David Garrett & Associates

RE: Response to Regulatory Review Comments
C&D Landfill, Inc. Phase 2 Permit to Construct
NDENR Solid Waste Permit #74-07

Settlement with Increasing Stress

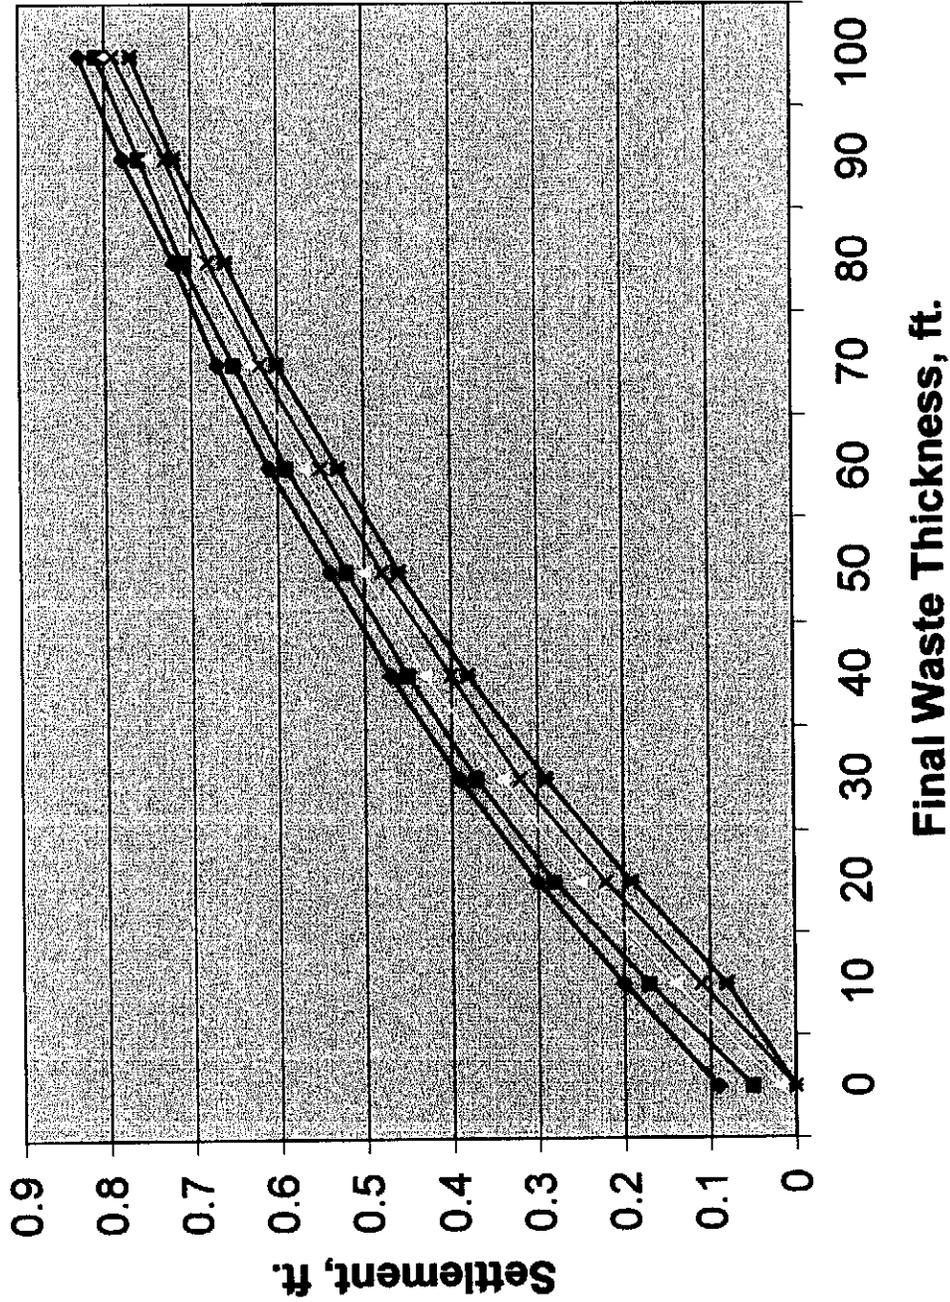
22. The settlement calculations were based on a preliminary drawing. The final waste thickness of 85 feet has been verified and the calculations have been amended accordingly (**Attachment 7** to this document, replaces relevant portion of **Appendix 7**). **Section 6.2** has been amended to discuss variables and assumptions. Based on the grading plan and these calculations, the post-construction settlement will maintain a minimum separation of 4 feet.

This analysis charts the anticipated settlement beneath final slopes (i.e., variation on additional stress), based on the foregoing soil profile, to be used for determining required additional base grade separation at initial construction
